PLANNING COMMISSION AGENDA
Monday, March 28, 2022 at 6:00 p.m.
Caledonia Village Hall – 5043 Chester Lane

PLAN COMMISSION REPORT

Description: Review a request for a conditional use and a proposed building, site, and operation plan to construct a ±28,638 square-foot speculative commercial building with 14 acres of outdoor storage for the parcel located north of 7301 USH 41.

SITE PLAN **C1.0**

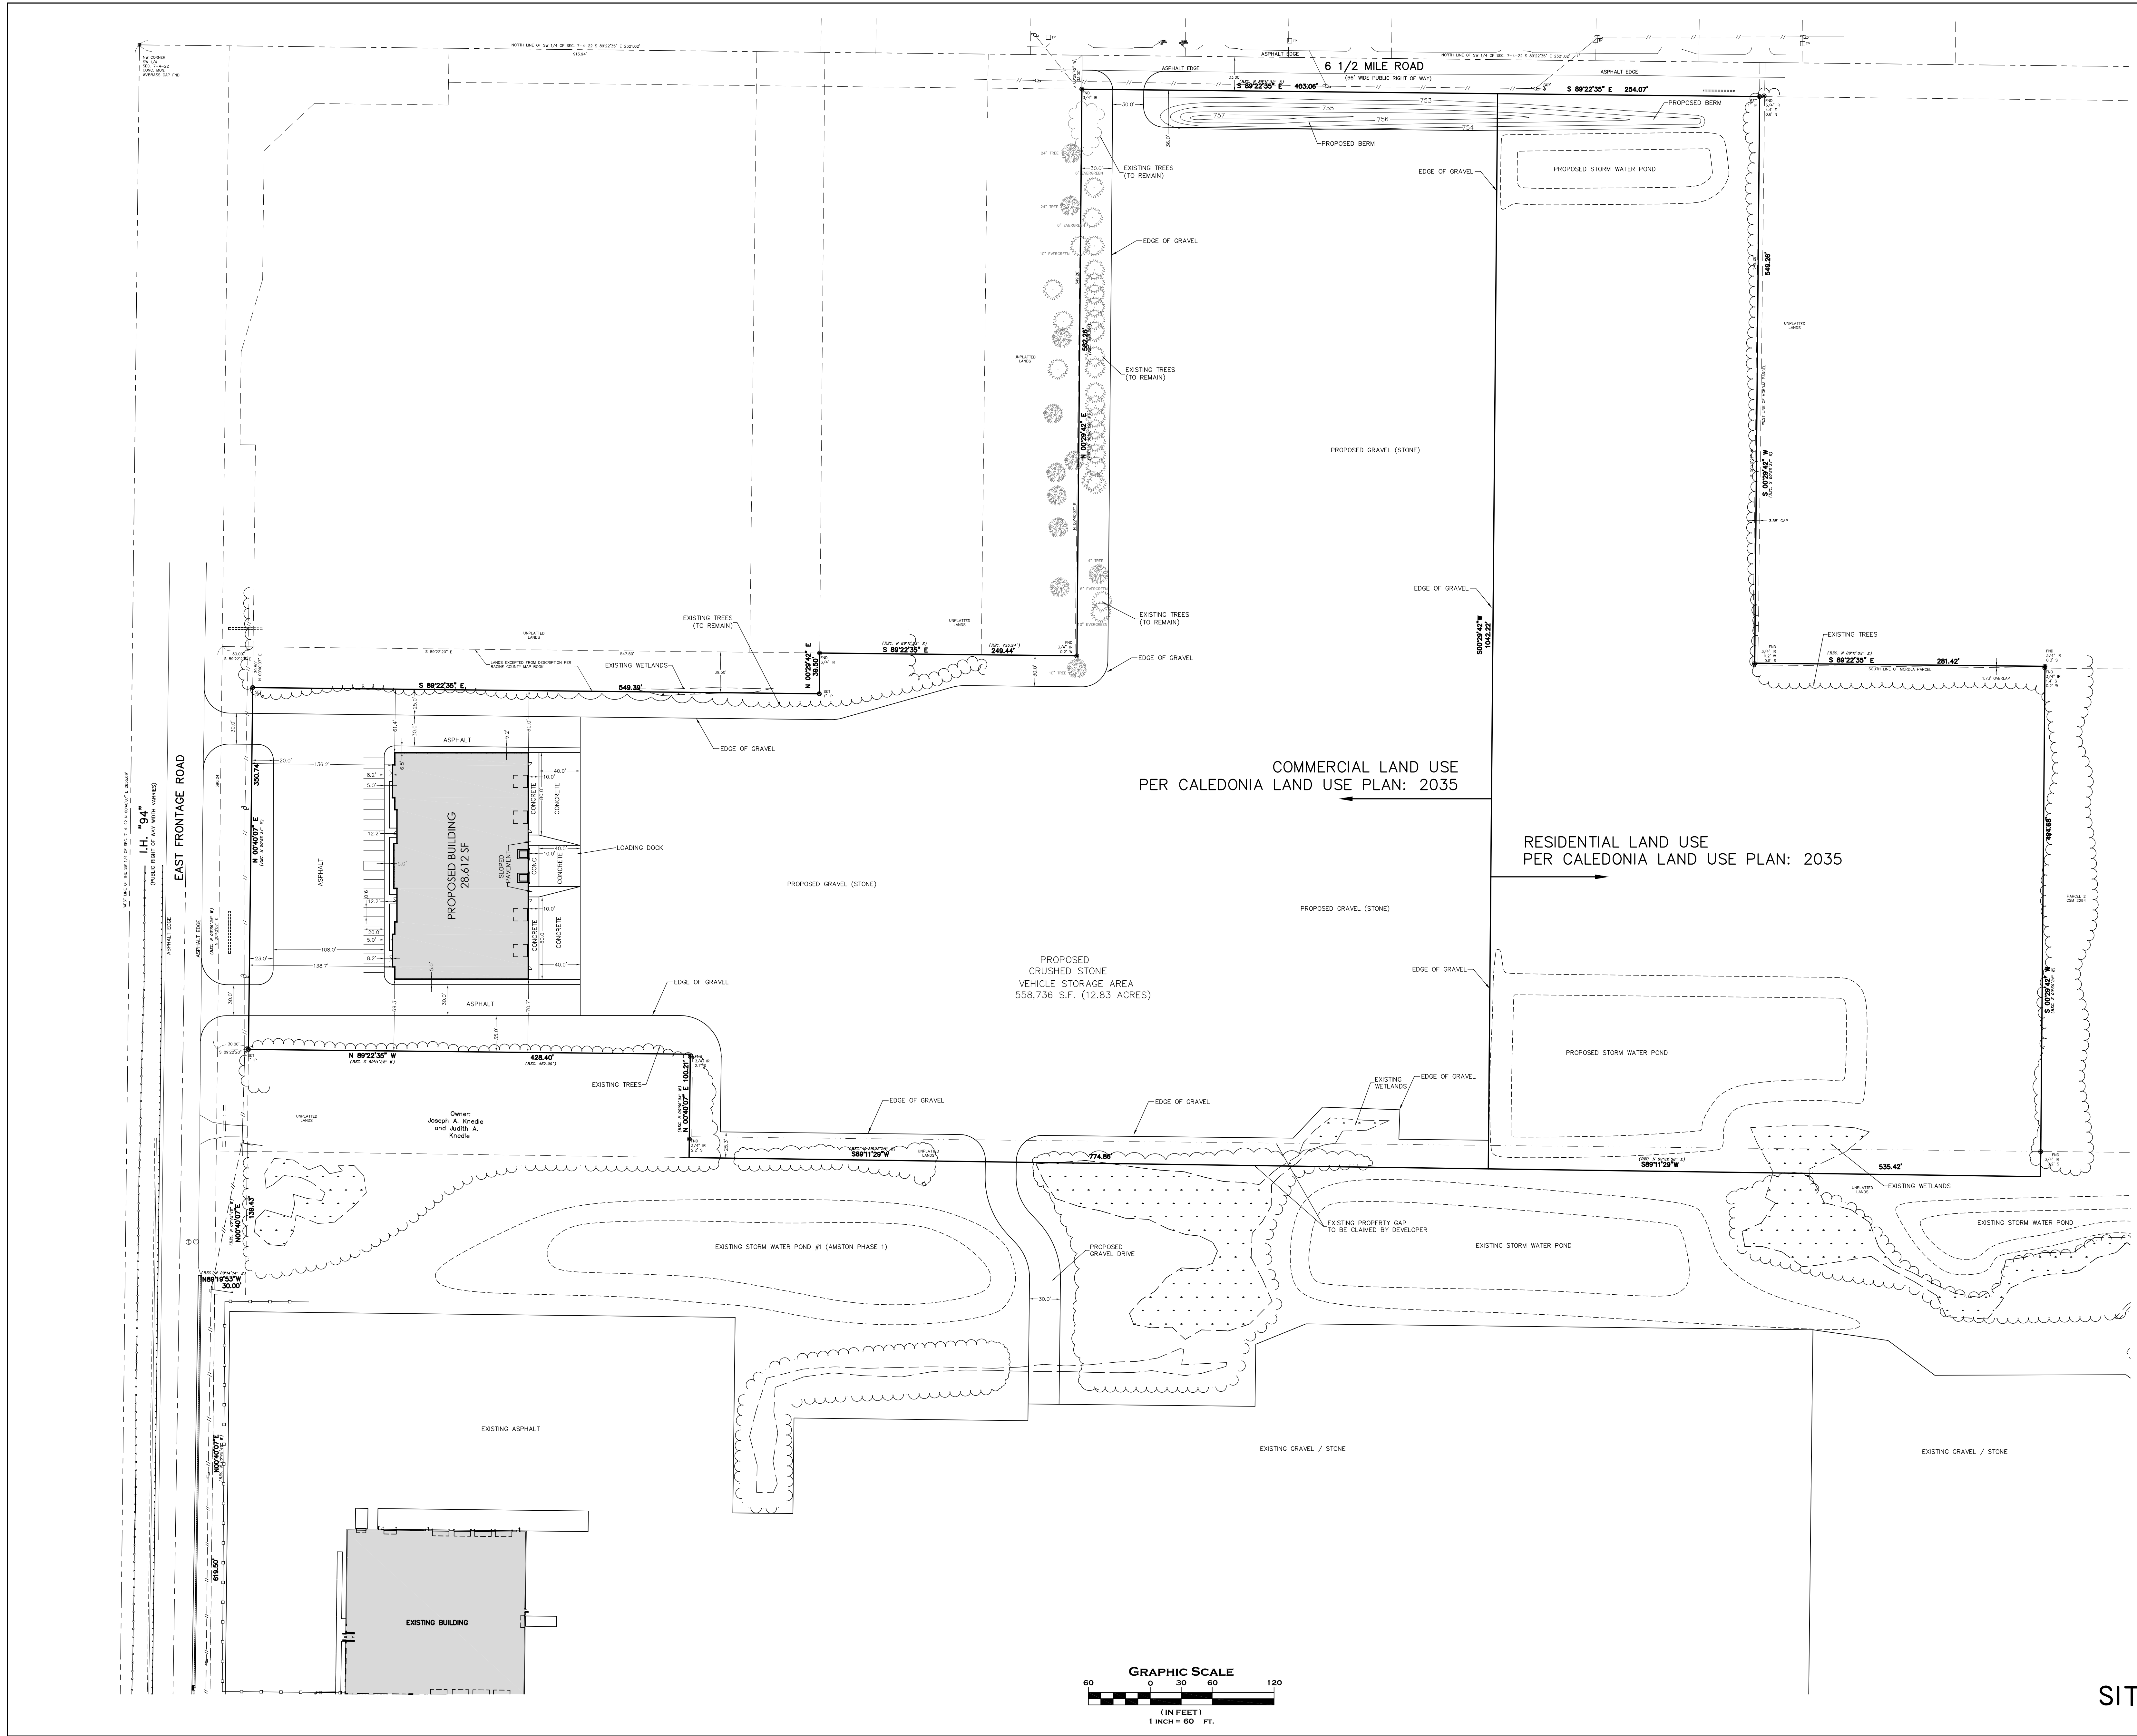
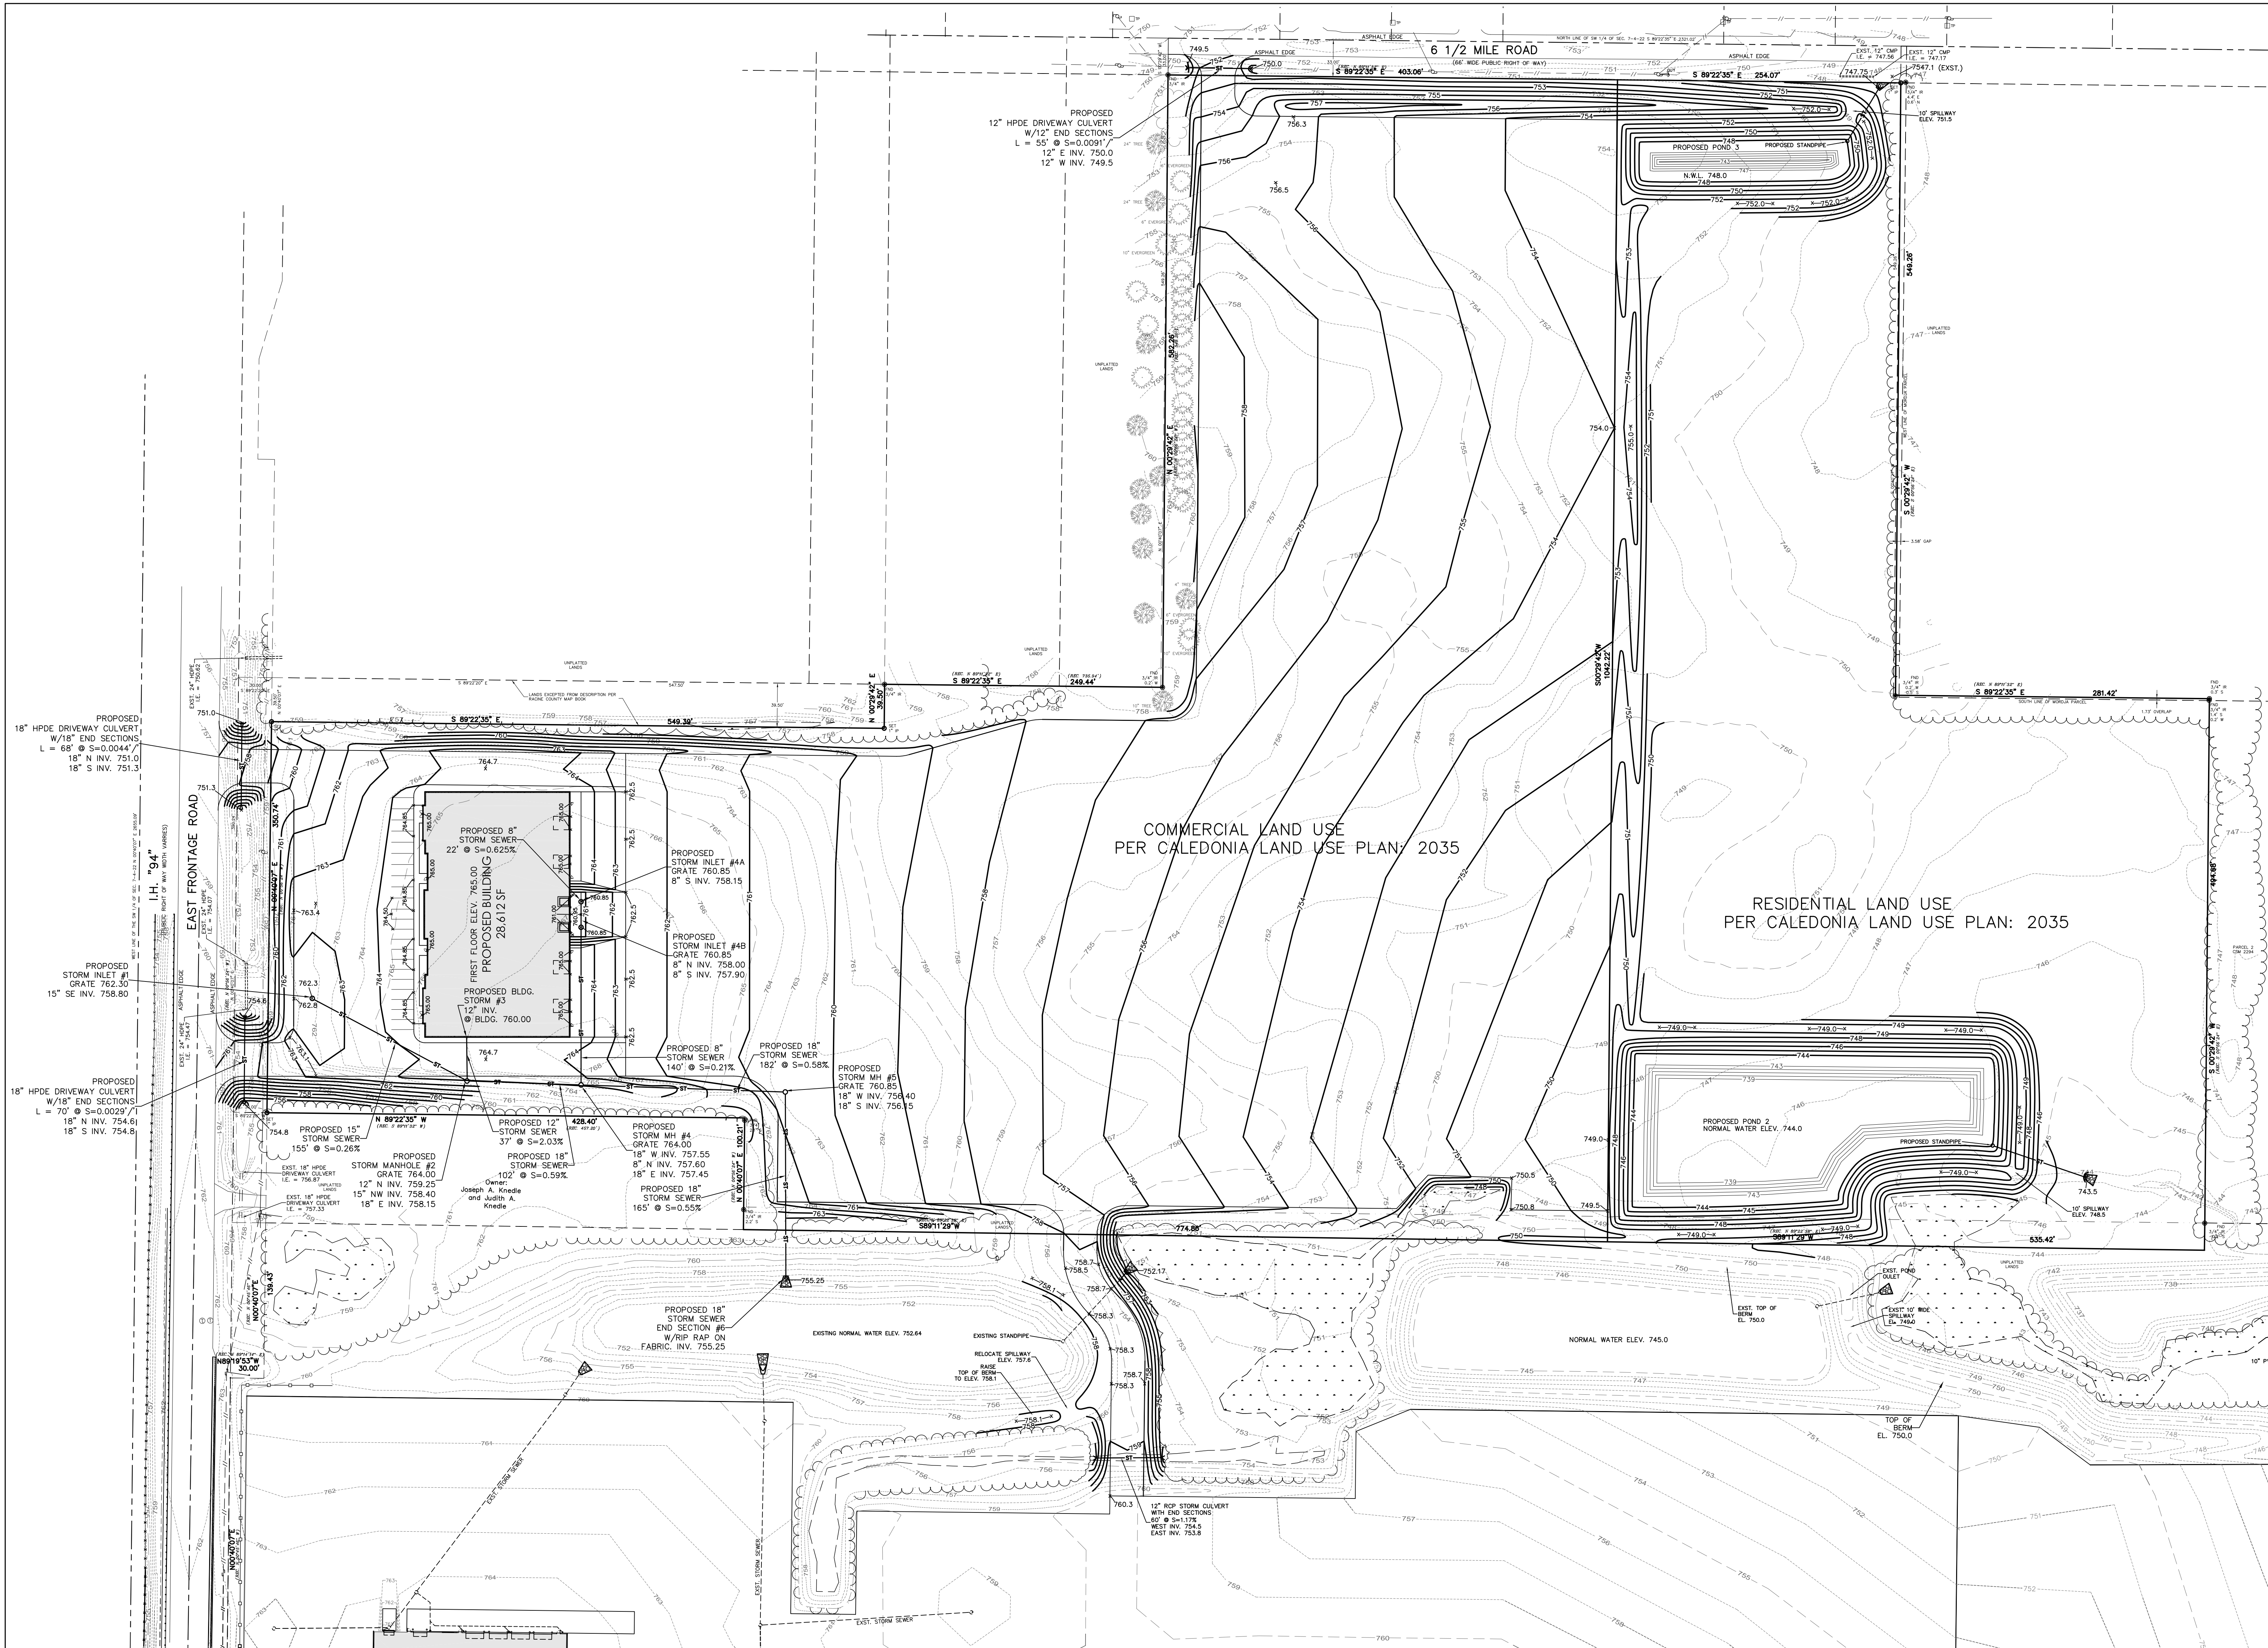
Staff recommends reducing the gravel area to approximately 5.3 acres in rear yard so that outdoor parking of trailers is set back from the north lot line approximately 550 feet and reduced 300 westwards. When the property is further developed, an expansion of the gravel parking area can be considered as part of a future site plan review. Removing the gravel parking area on the north side of the property will provide a buffer between the business operation and residents to the north. A 30-foot-wide gravel access road would be allowed with the first 30 feet being asphalted to reduce the dragging of gravel and debris onto the Village Road. The gravel area will be connected to the parcel to the south through a gravel driveway. A cross access easement will need to be recorded and noted on the site plan. Prior to installation of the gravel access road to the south, the applicant will need to receive approval from the DNR to fill wetlands in the area. In the conditions of approval, staff is requiring that the applicant identify a road reservation in this area to comply with the WisDOT highway access plan.

- The proposed development is inconsistent with the WisDOT Highway Access Plan for the area. As a result, a road reservation should be identified on the parcel going north south to be consistent with this plan.

- A cross-access and maintenance easement for the connecting driveway needs to be submitted and shown on the site plan.
- Pave the first 30 feet of driveway entrance for 6 ½ Mile Road to reduce gravel and debris dragged onto the Village Road.

- Illustrate on the site plan where light and heavy asphalt will be installed
- Modification to the site plan to include a swale along the south side of the parcel to prevent runoff to the home on the south.
